# CITY OF ALBUQUERQUE

**RE: Nuevo Atrisco  
7909 Central Ave. NW  
Permanent C.O. - Denied  
Engineer's Certification Date: 9/4/20  
Engineer's Stamp Date: 12/3/19  
Hydrology File: K10D058**

Based on a site visit on 9/11/20, this certification cannot be approved until the following issues are addressed:

**CG-102**

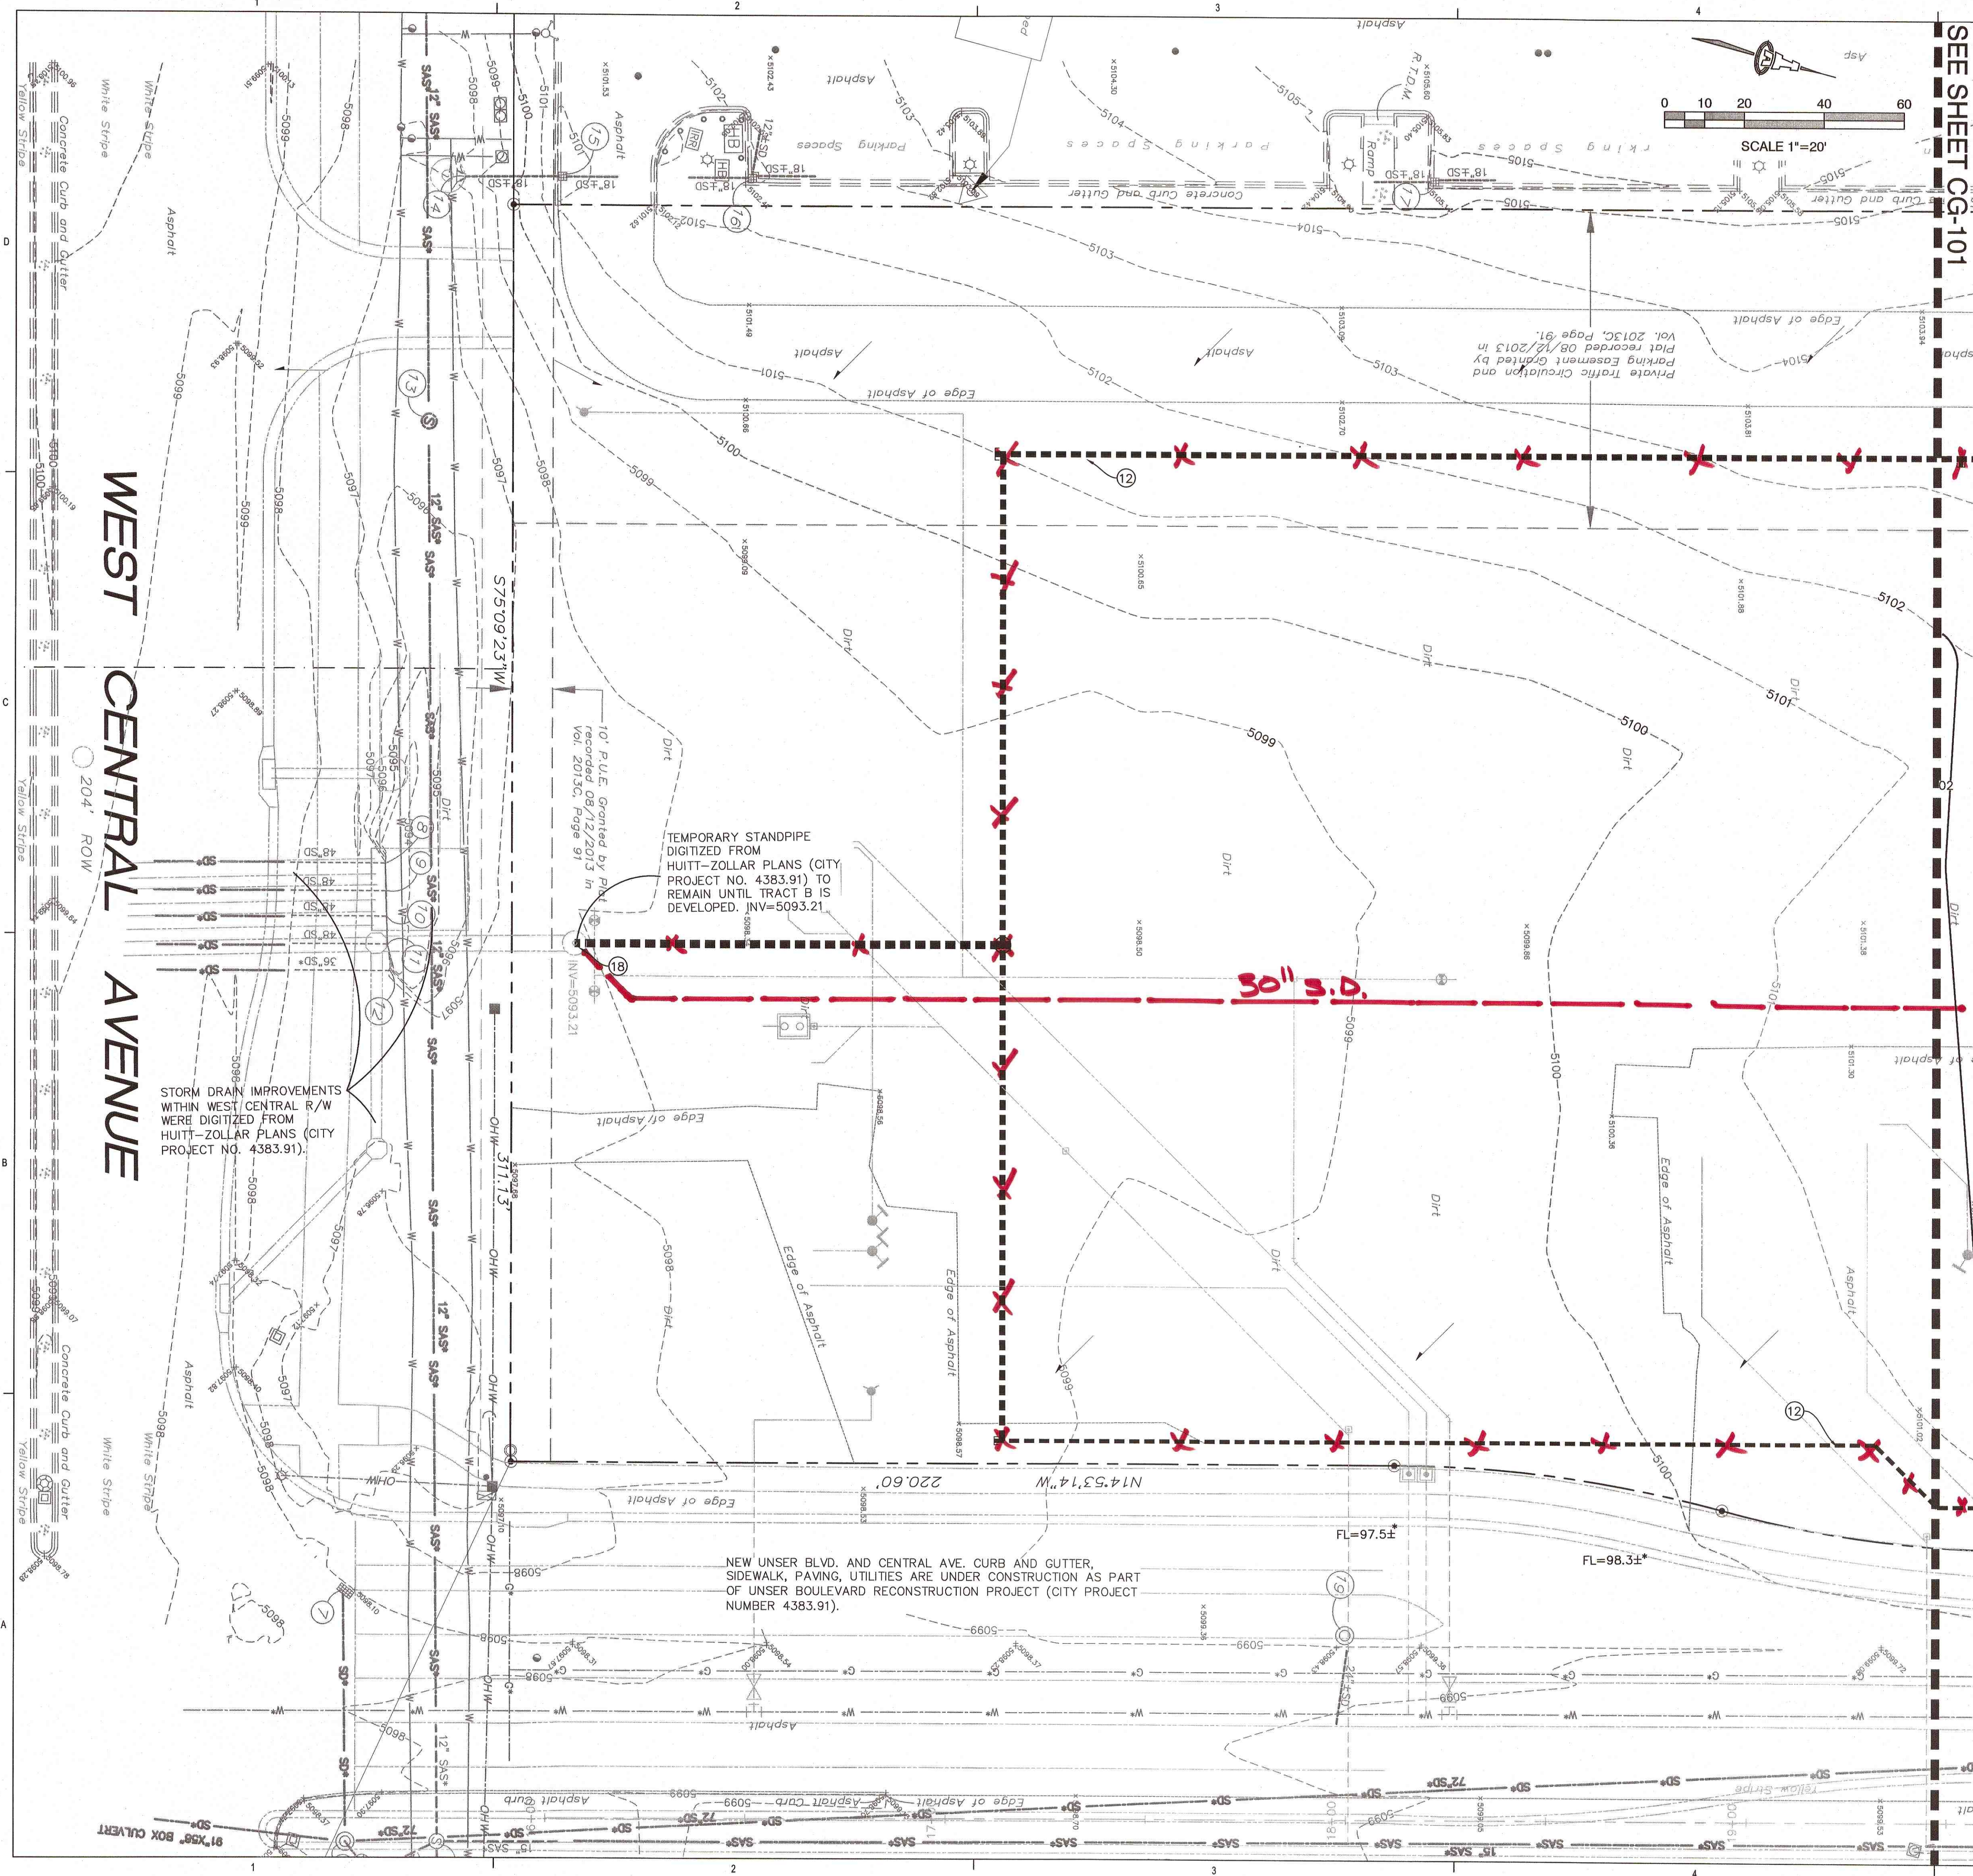
1. The building roof discharge points per keyed note 5 on the north side of the building were not evident.
2. The erosion control and rundowns from these roof discharge points on the north to the pond on the north side of the site were not in place.
